**PLANNED UNIT DEVELOPMENT  
& SUBDIVISION STAFF REPORT****May 4, 2017**

<b><u>DEVELOPMENT NAME</u></b>	Brewer- Rhodes Subdivision
<b><u>SUBDIVISION NAME</u></b>	Brewer- Rhodes Subdivision
<b><u>LOCATION</u></b>	2695 Government Boulevard Northeast corner of Howell Avenue and Government Boulevard extending to the West side of Merwina Avenue, 91' ± North of Howell Avenue.
<b><u>CITY COUNCIL DISTRICT</u></b>	District 5
<b><u>AREA OF PROPERTY</u></b>	2 Lots / 0.8 ± acres
<b><u>CONTEMPLATED USE</u></b>	Planned Unit Development Approval to amend a previously approved Planned Unit Development to allow shared access and parking between two building sites, and to create two legal lots or record from one existing legal lot.
<b><u>TIME SCHEDULE FOR DEVELOPMENT</u></b>	None given.

# SITE PLAN

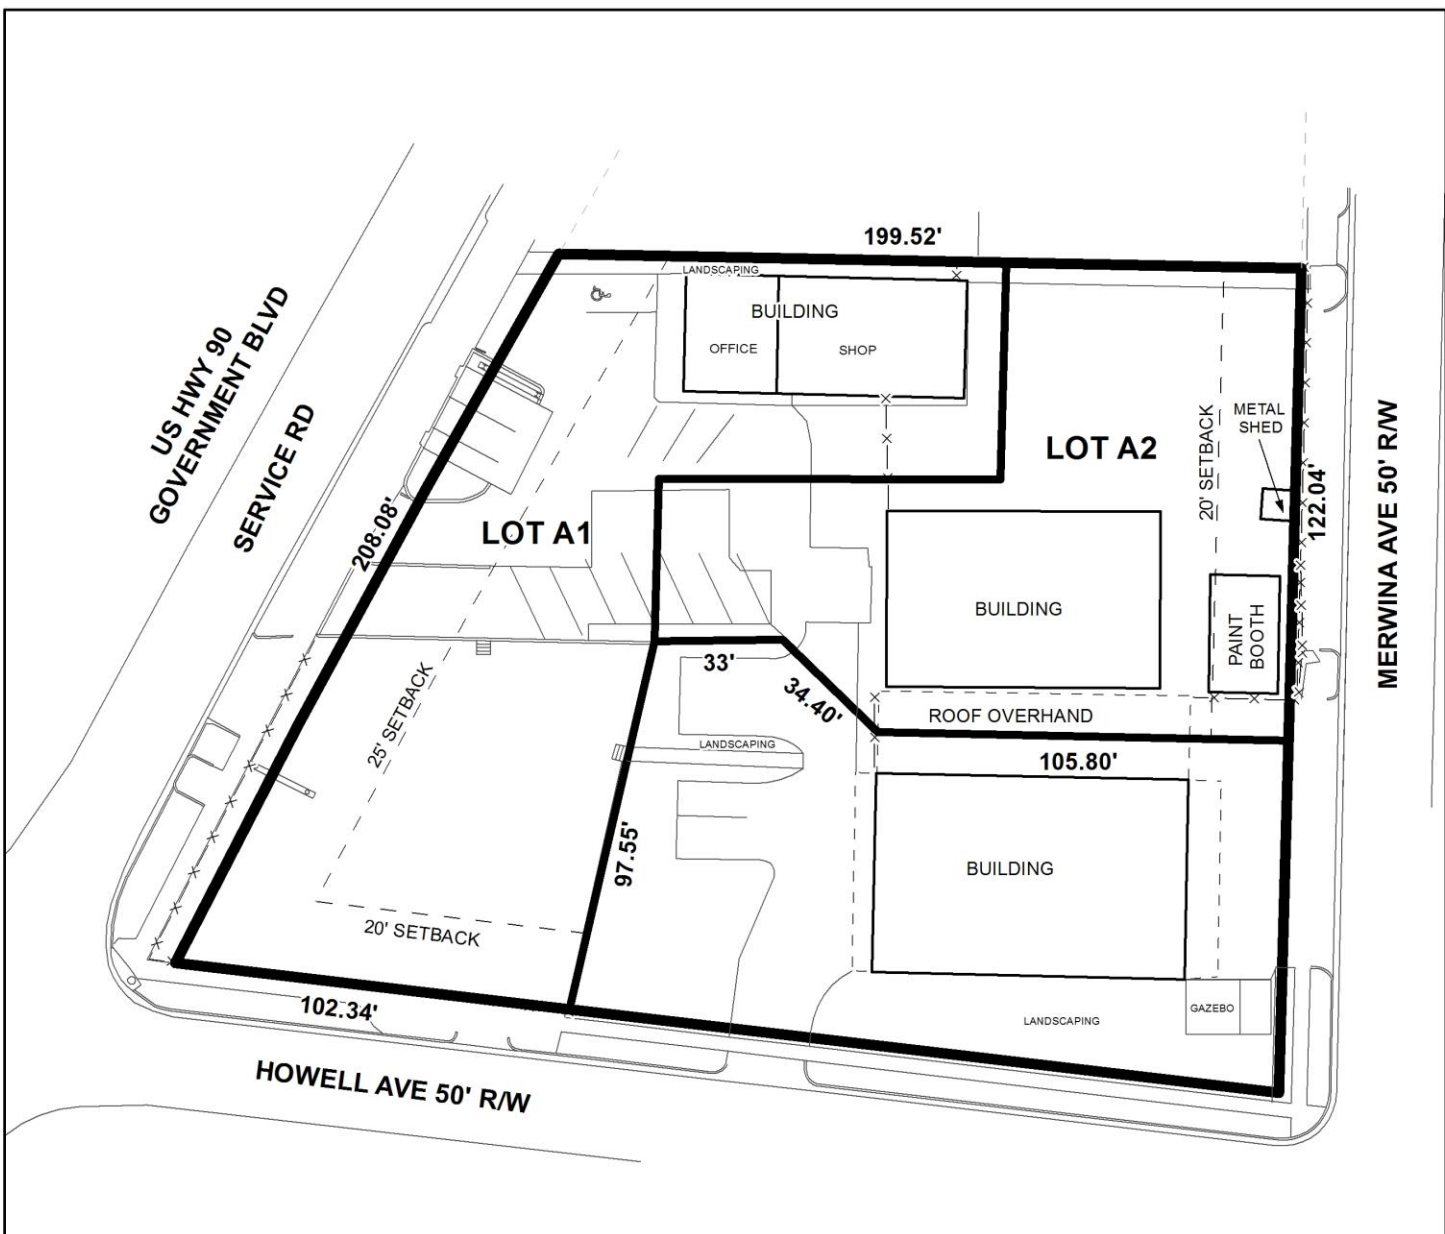
A sidewalk is depicted on some areas of the site plan, but is shown as a partial sidewalk that runs onto existing concrete in other areas located on the site. At the time of any new development or redevelopment, a sidewalk along all street frontages of the property will be required or a sidewalk waiver will need to be submitted.

Furthermore, it should be pointed out that the site plan depicts the property to the south, Lot B, as “not included”, however, after reviewing aerial photos the additional property to the south of the subject site will still have cross access, thus the property to the south should be included in the PUD application. The PUD application should be revised to include all properties that partake in cross access and shared access among the sites.

*It should be noted that the site plan does not depict the minimum building setback line along both Howell and Merwina Avenues for the entire length of the property as depicted on the recorded plat. The site plan should be revised to depict the 20' minimum building setback line. The site plan also does not illustrate the lot size of Lot B in square feet or acres. The site plan should be revised to depict the labeling of all three lots in square feet and acres.*

- 1. revision of the site plan to depict the 20' minimum building setback line along Howell and Merwina Avenues, per the previously recorded plat;*
- 2. retention of the 25' minimum building setback line along Government Boulevard;*

- 5. revision of the site plan retention of the labeling of the lot sizes in square feet and acres, or the furnishing of a table providing the same information;*
